**CITY OF OREGON  
OREGON, OHIO  
WATER TREATMENT PLANT – CONCRETE REPLACEMENT PROJECT**

**Addendum No. 2  
May 8, 2024**

To: Prospective Bidders  
From: **ARCADIS U.S., Inc.**  
**One Seagate, Suite 700**  
**Toledo, Ohio 43604**  
Owner: **City of Oregon**  
**Department of Public Service**  
**5330 Seaman Road**  
**Oregon, Ohio 43616**  
Subject: **Water Treatment Plant – Concrete Replacement Project**

SEDIMENTATION BASINS PLANT-1  
**WATER TREATMENT  
PLANT IMPROVEMENTS  
OREGON, OHIO**

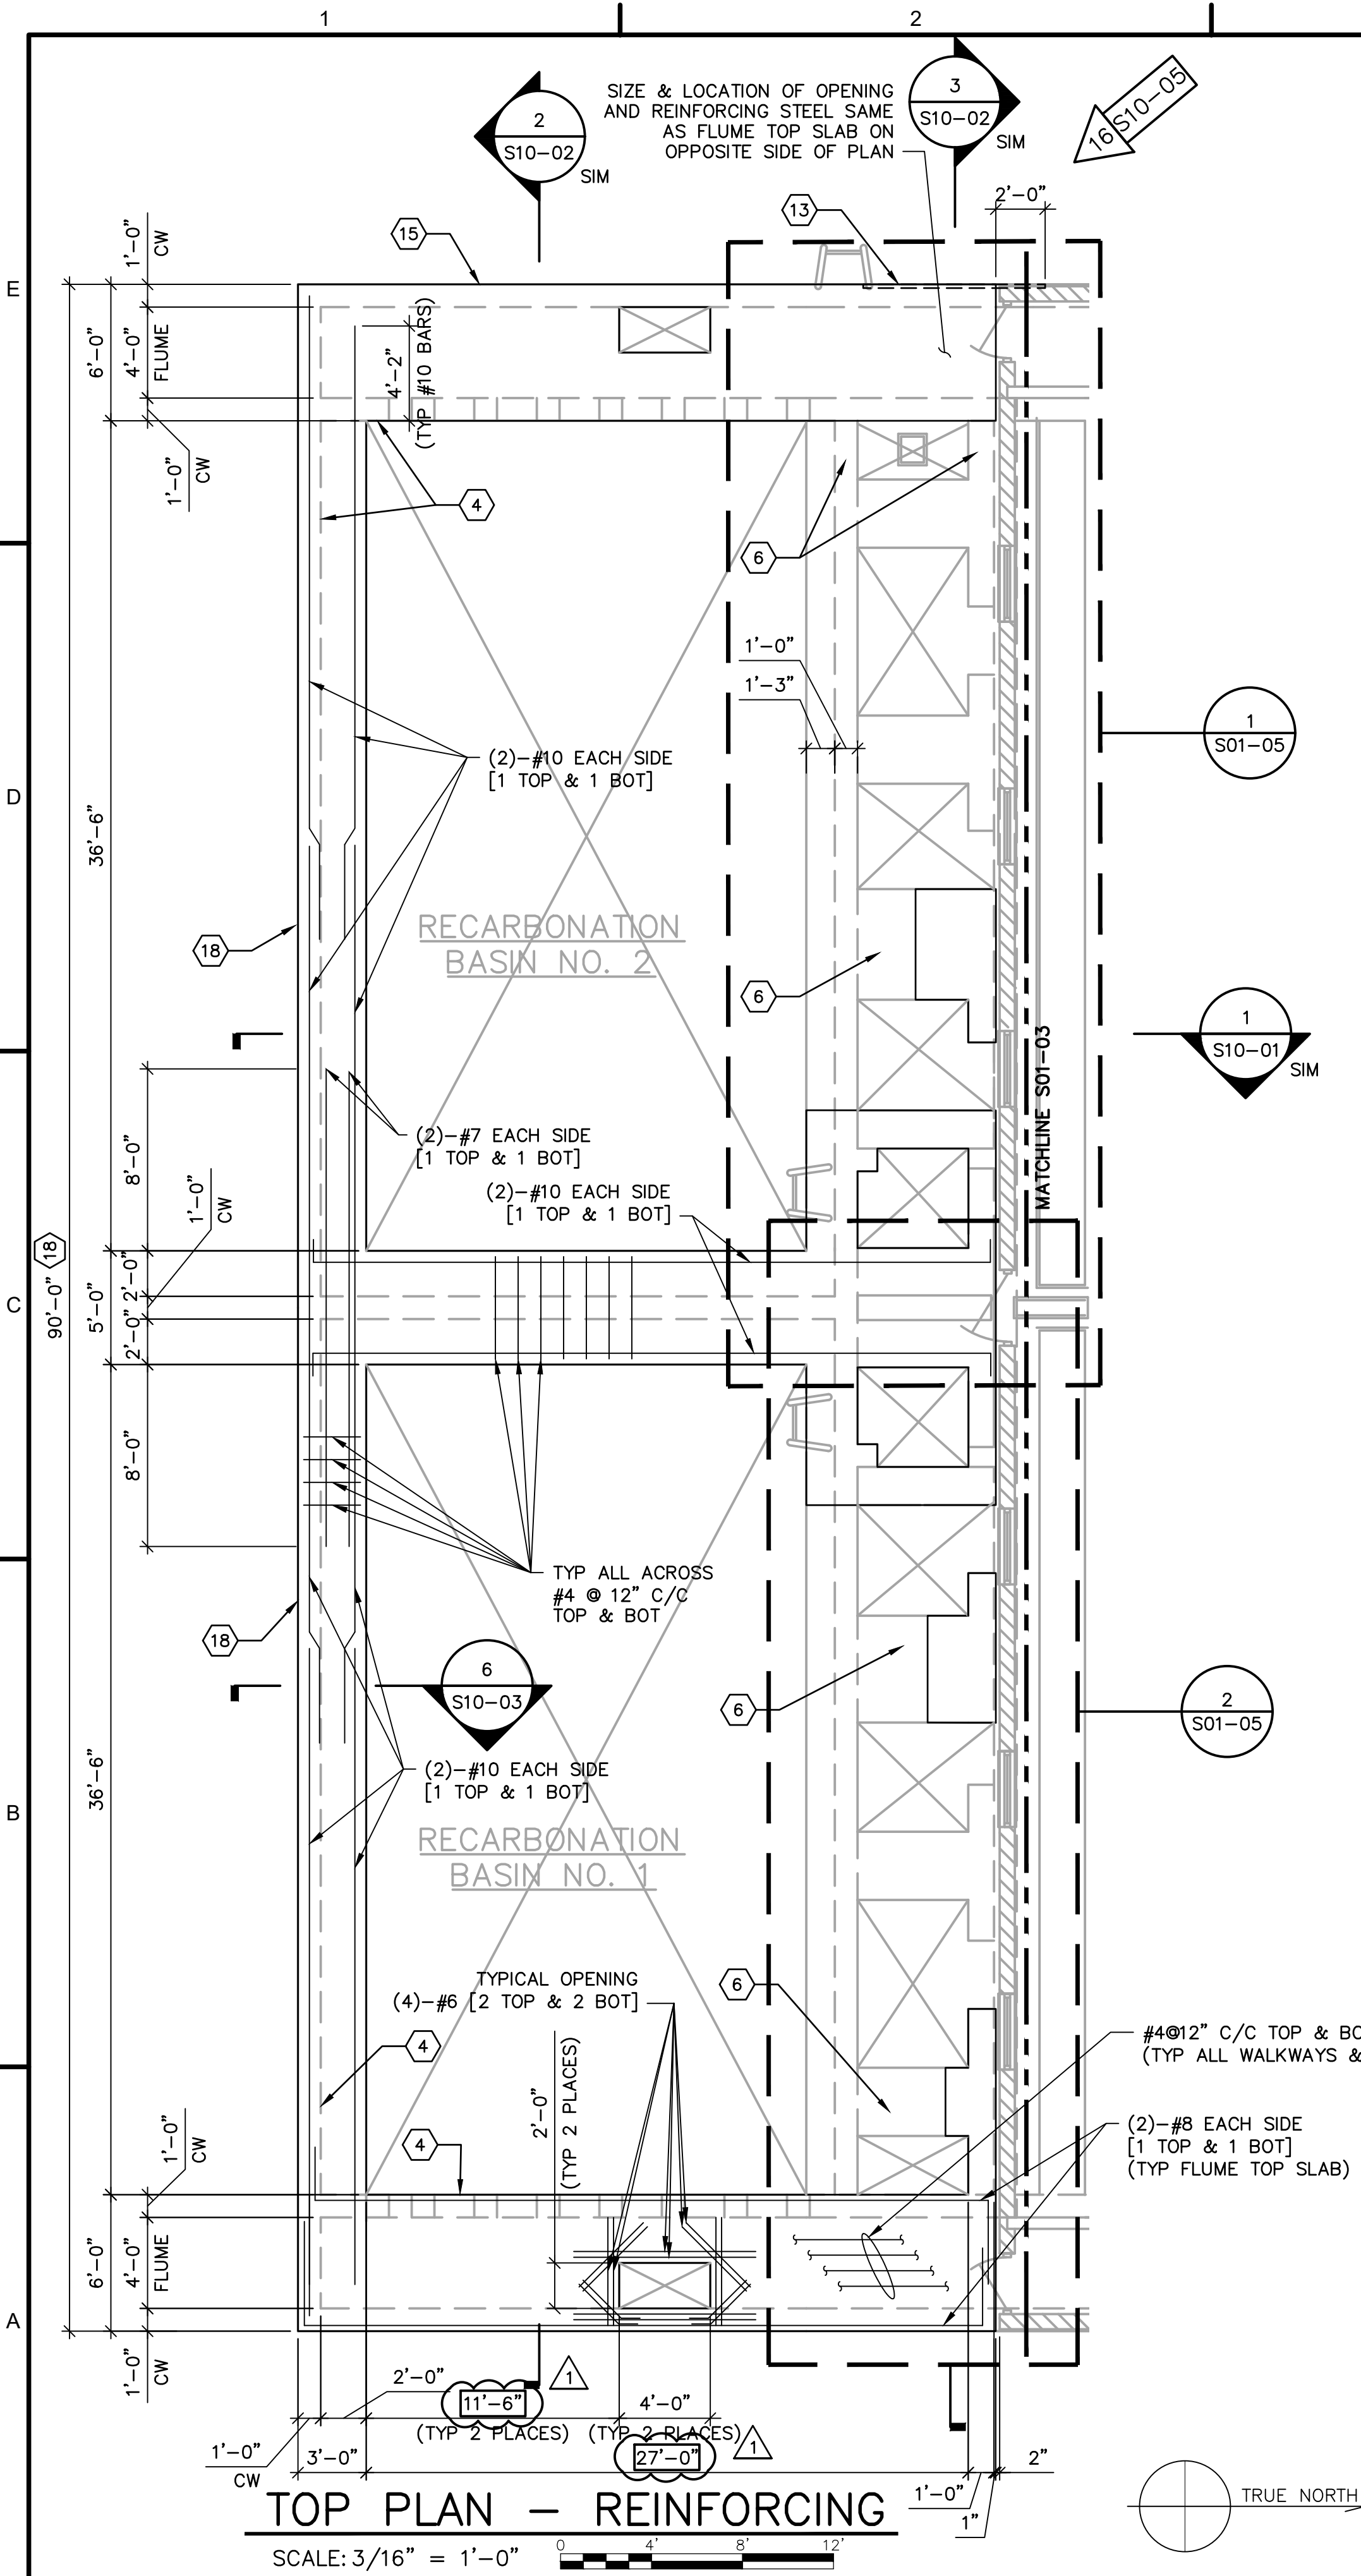
17. Instead of "piecemealing" the concrete replacement areas of the elevated walkway slab immediately south of the existing Launder Building (for the South Recarbonation basins – shown on D01-03), would you be willing to consider replacing all the concrete in this area? If this approach was acceptable, what would the resteel requirements be for this elevated walkway slab? This same question applies to the similar elevated walkway slab immediately north of the existing Launder Building (for the North Recarbonation basins – shown on D03-03).

Response: Arcadis and the City are willing to consider removing and replacing the entire concrete elevated walkway slab in this area if it simplifies the demolition and construction process and can be achieved with same or less construction cost. See attached 2002 record drawing with markups showing the required elevated walkway slab reinforcement and dowel requirements associated with this approach.

S01-01

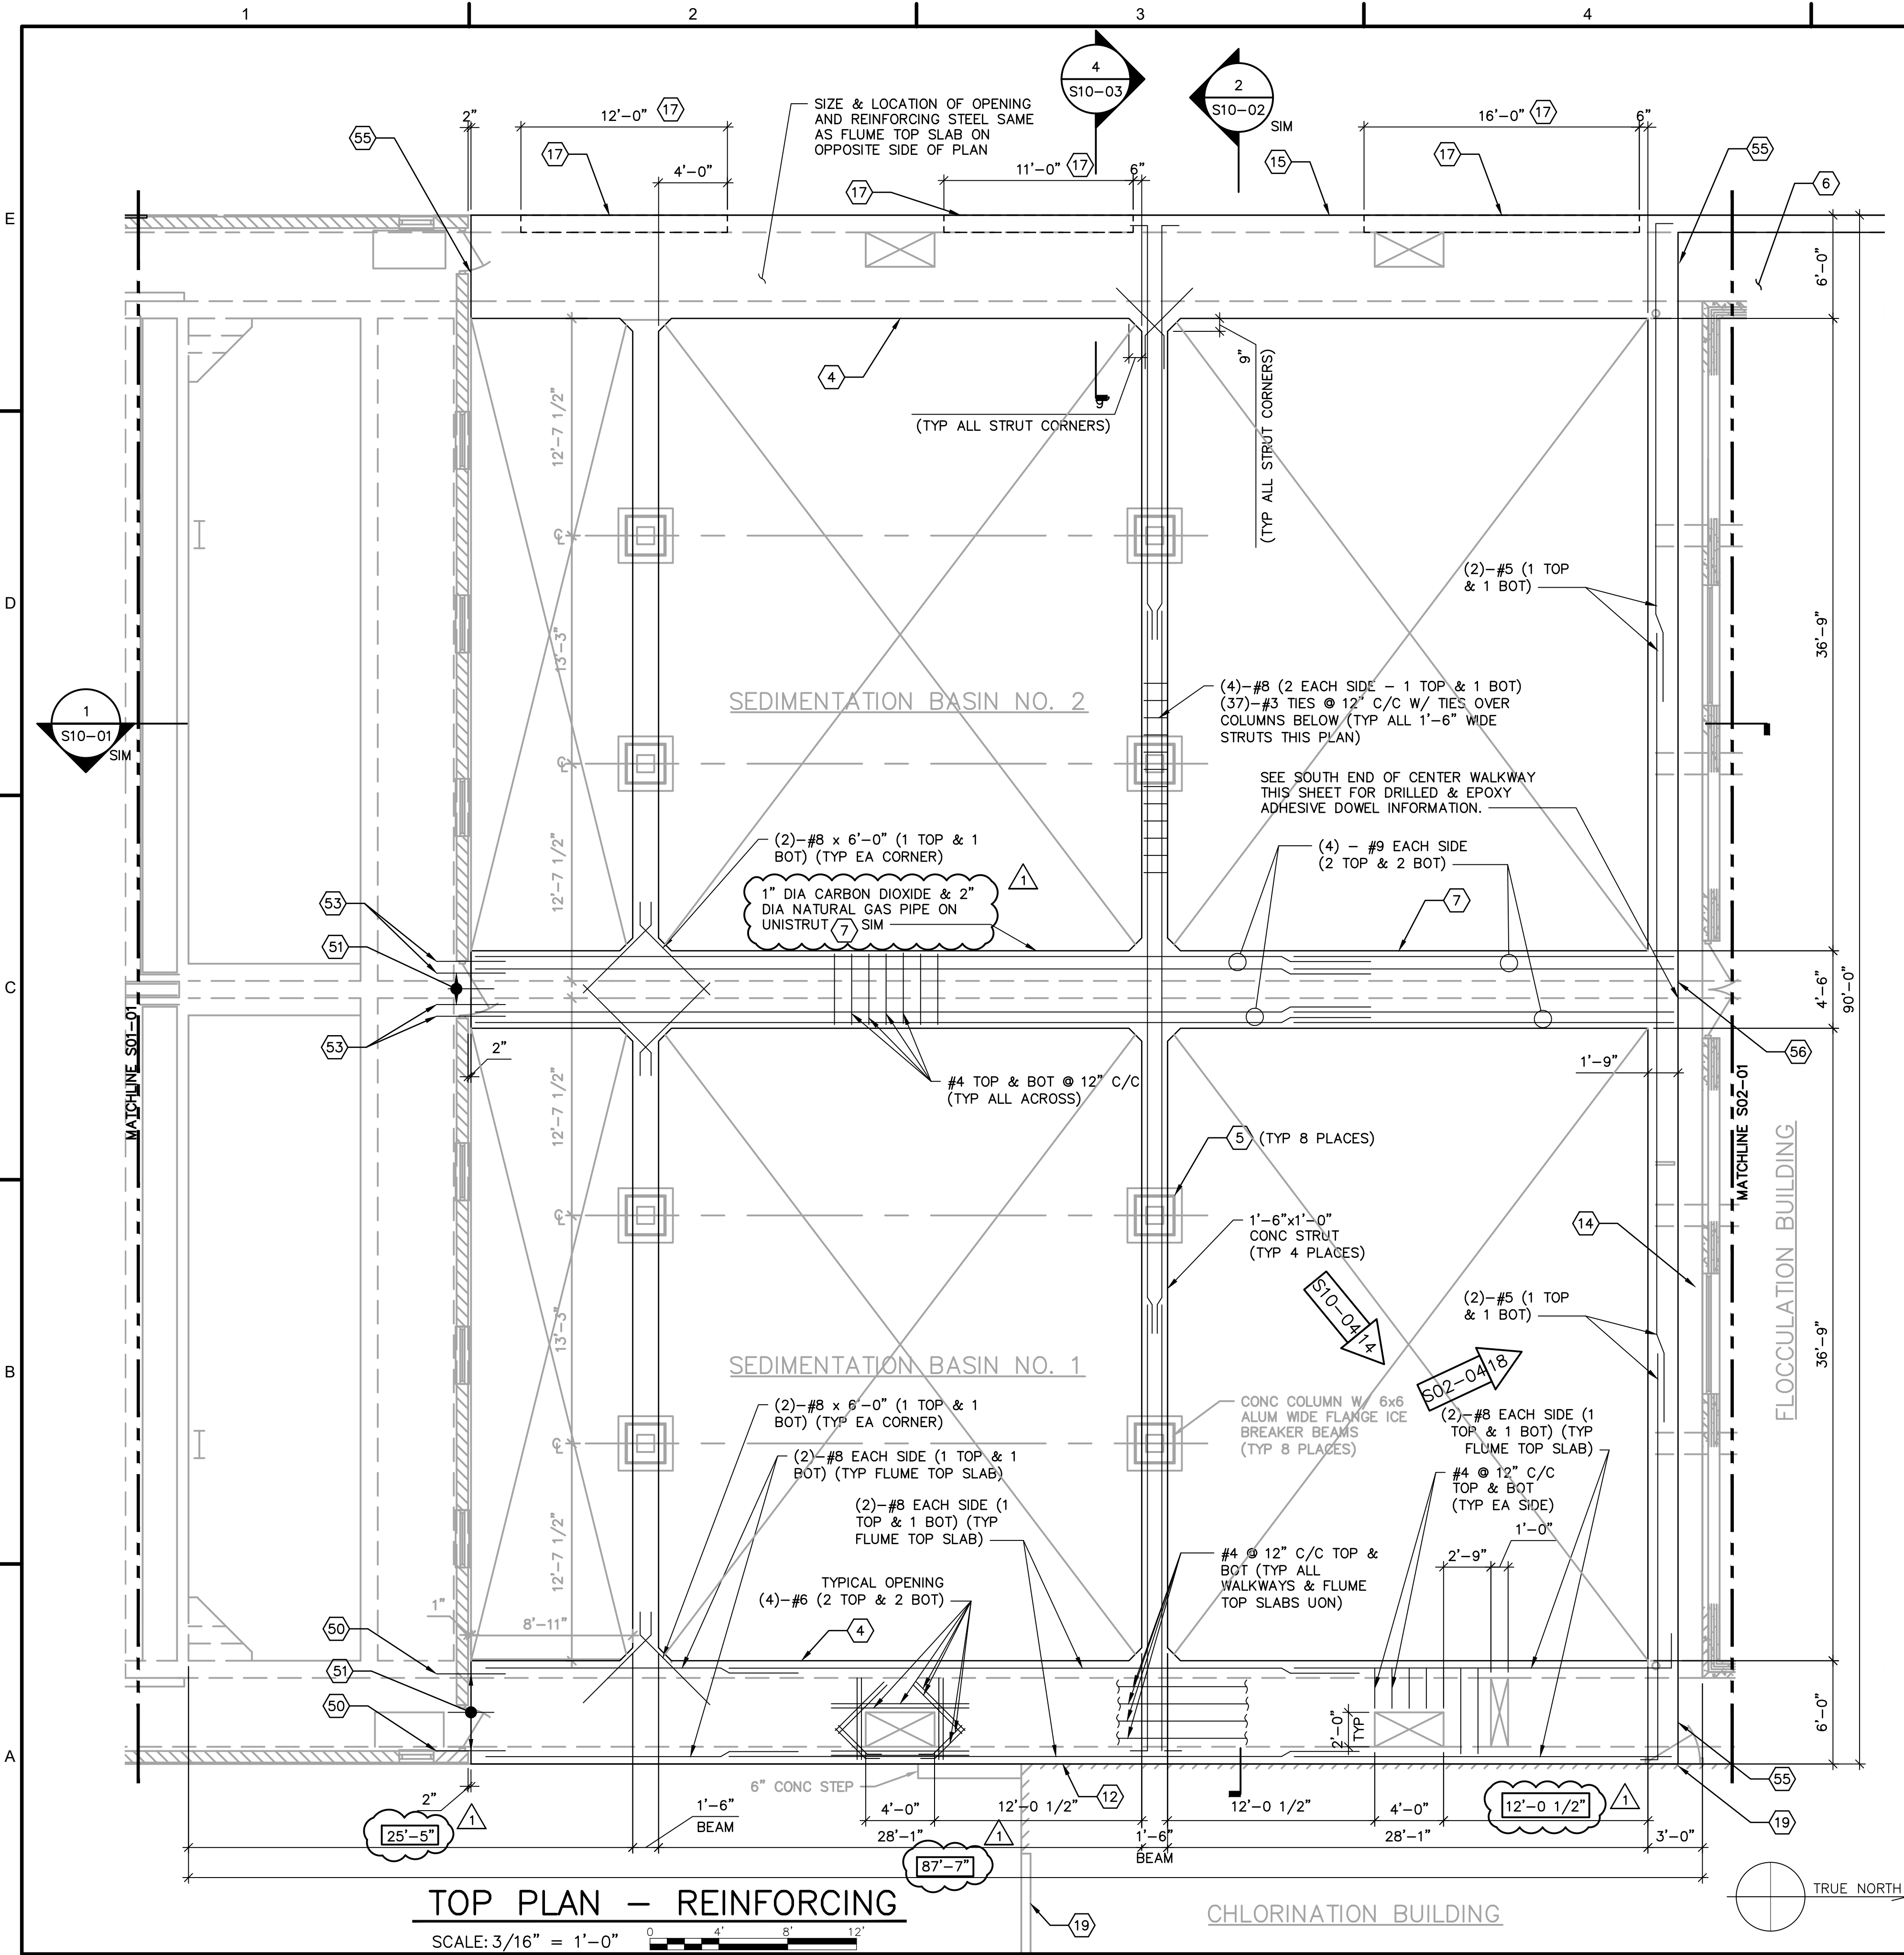
- 1.12 Drawing S01-01, RECARBONATION BASINS (SOUTH) – TOP PLAN - REINFORCING - Delete this sheet in its entirety and substitute revised Drawing S01-01, included with this Addendum No. 2.

4. The scale for drawing S01-01 is listed as 3/16" = 1'-0". All dimensions appear to scale correctly aside from the 27'-0" dimension and the 11'-6" dimension shown on the East side of the Recarbonation Basin. The 27'-0" annotated dimension scales to 26'-5 1/2" and the 11'-6" annotated dimension scales to 11'-1 1/2".

a. Can you please advise what these dimensions should be?

*Response: The specific dimensions referenced by the contractor are correct but not drawn to scale. This drawing has been revised and re-issued in Addendum No. 2 to provide clarity to this issue.*

11'-6" - DIMENSIONS WITH BOXES AROUND THEM IN PLAN ARE CORRECT BUT NOT DRAWN TO SCALE. THESE SAME DIMENSIONS WITH BOXES ALSO APPLY TO SHEETS S01-02 AND D01-01.
